STAFF RECOMMENDATION

D Hamilton
NCPC File No. 5907

MARTIN LUTHER KING, JR. MEMORIAL TIDAL BASIN, WEST POTOMAC PARK Washington, D.C.

Submitted by the National Park Service

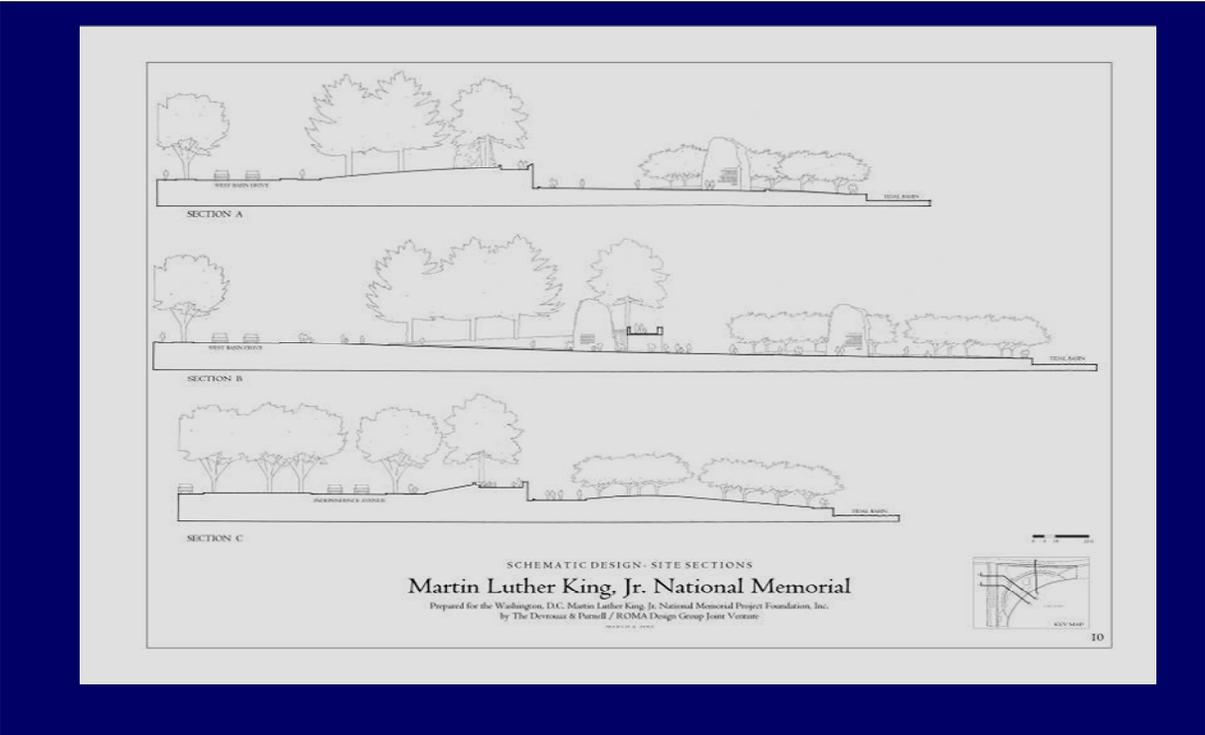
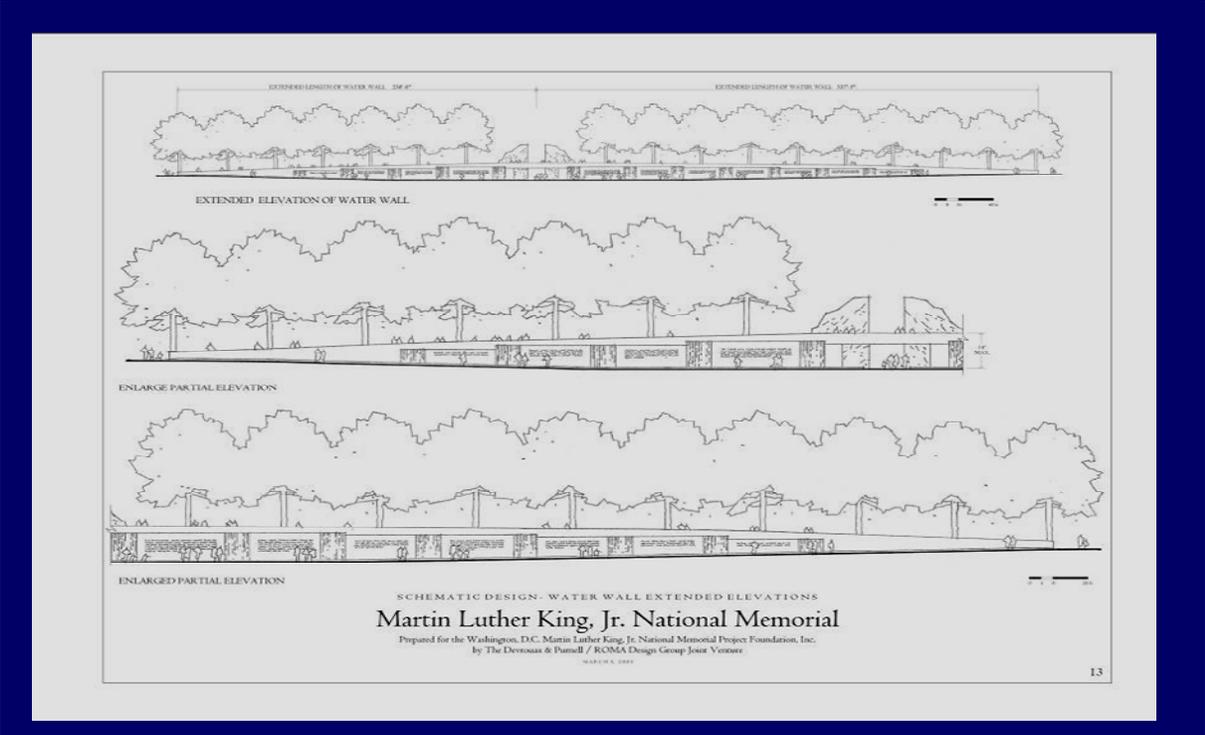
- As proposed, the bridge portion of the Memorial Walk adjacent to the Mountain of Despair has a major adverse impact on this signature element. The strength of the Mountain of Despair and Stone of Hope relationship is that the visitor should be able to clearly “see” that the Stone of Hope has emerged from the Mountain of Despair. The bridge element severely interrupts the dynamic visual tension that is intended to be created by these elements. Additionally, the horizontality of the bridge diminishes the necessary strong visual verticality of these stones. The bridge would also provide a place for visitors to stand above the primary important entrance to the memorial, thereby, further reducing the strong relationship between the Mountain of Despair and the Stone of Hope. NPS and the MLK Foundation should remove the bridge portion of the memorial walk.

- The main entrance walk area to the memorial goes from approximately 90 feet wide and narrows to approximately 10 feet wide when the visitor reaches the Mountain of Despair. This narrow passageway creates a high potential to create a bottleneck as visitors pause in the narrowest portion to read inscriptions that would be located on the flanking polished sides of the Mountain of Despair.

- Redesign the entrance portal between the Mountain of Despair to remove the bridge of the Memorial Walk that interrupts views to the Stone of Hope and beyond, and to provide more space for visitor movement in this entry area.
- Provide more detailed photo simulations that clearly indicate the visual impact that the berm of the proposed memorial would have on views to the Tidal Basin and beyond.
- Coordinate with NPS on the size, location, and programmatic requirements for the Ranger and Visitor Information Kiosk.

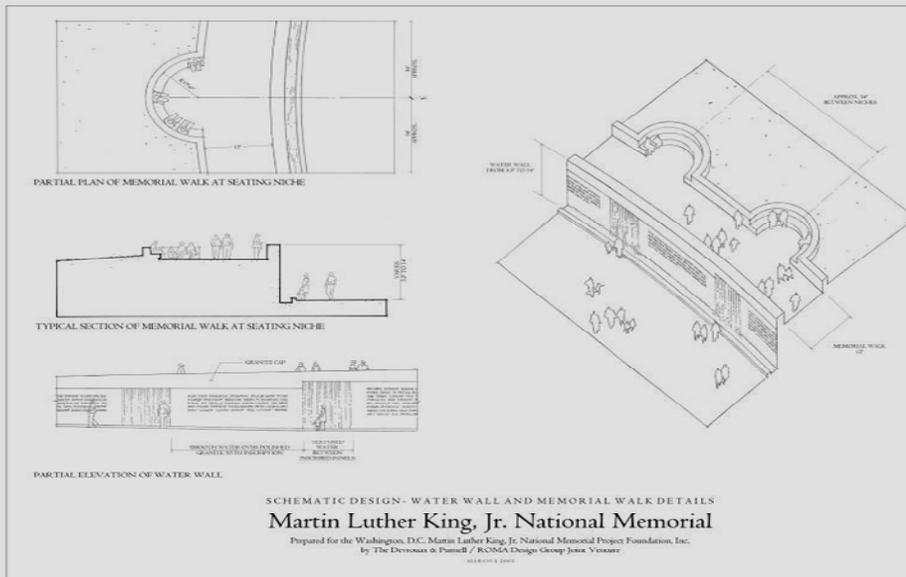
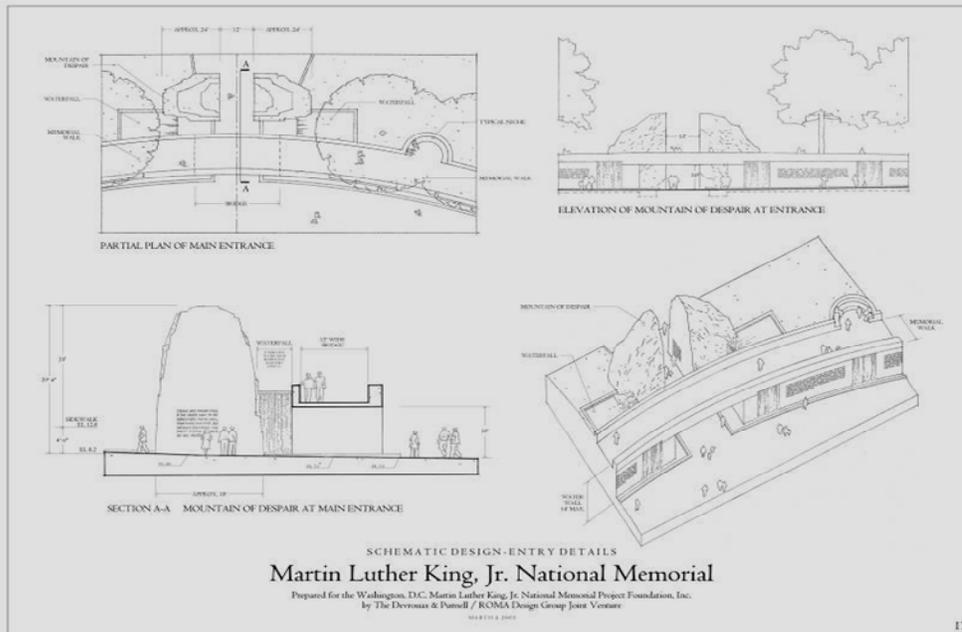
- The Mountain of Despair and the Stone of Hope are the signature elements of the memorial. At the entry portal, two stones are parted, and a single stone is pushed back in the horizon, appearing as the missing piece of what was once a single bolder. The Stone of Hope with the carving of Dr. King emerging, as the Stone of Hope emerged from the Mountain of Despair is a powerful relationship that is well conceived.
